From: Carrillo, Abiel X.
To: ["Scott Steffen"](#)
Subject: H13D025A - Sawmill Village Phase 2 - SPBP/SPS
Date: Thursday, December 15, 2016 3:45:00 PM

SITE DEVELOPMENT PLAN
FOR BUILDING PERMIT AND SUBDIVISION AMENDMENT
SAWMILL VILLAGE
BELLAMAH AVE NW AND 18TH ST
ALBUQUERQUE, NM

Re: Sawmill Village Grading and Drainage Plan
Engineer's Stamp dated 5-13-08 (H13/D025A)

SHEET SDP 3.0

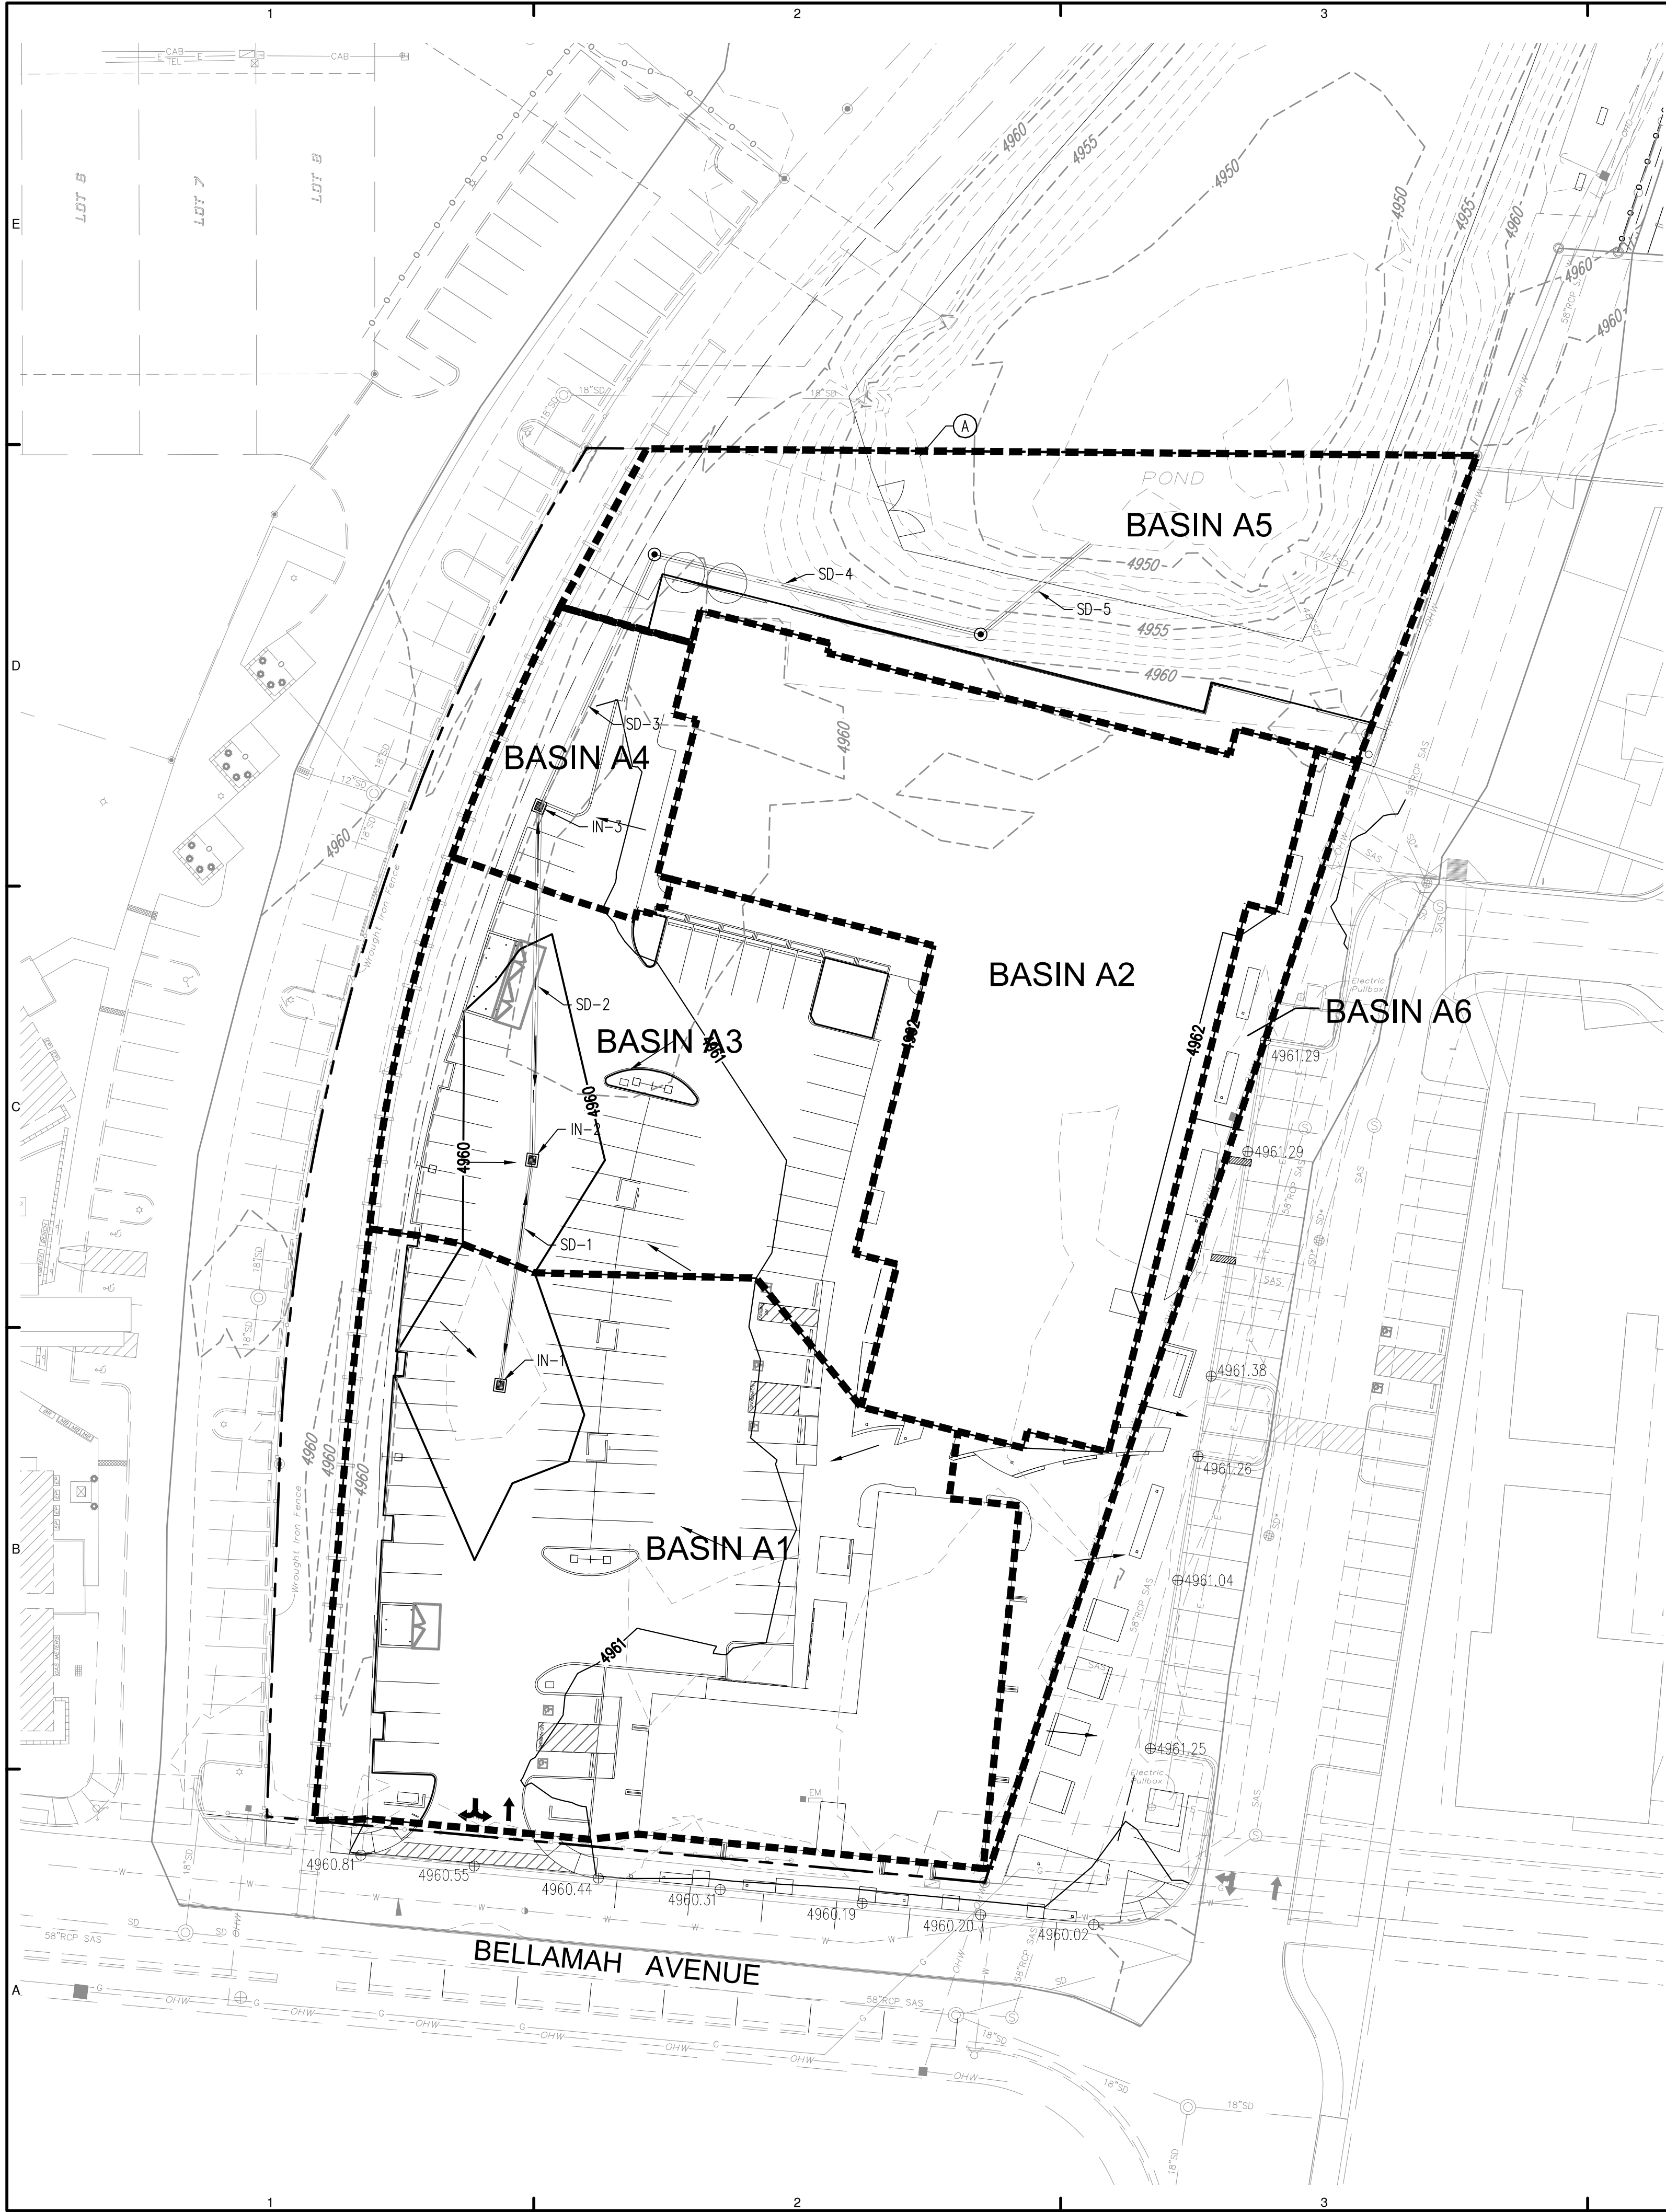
Just to formally closeout the submittal for DRB, the Site Plan for Building Permit and Site Plan for Subdivision Plans received 12-02-2016 are approved with the condition that the Work Order address the need for a curb-height water block at the Bellamah entrance.
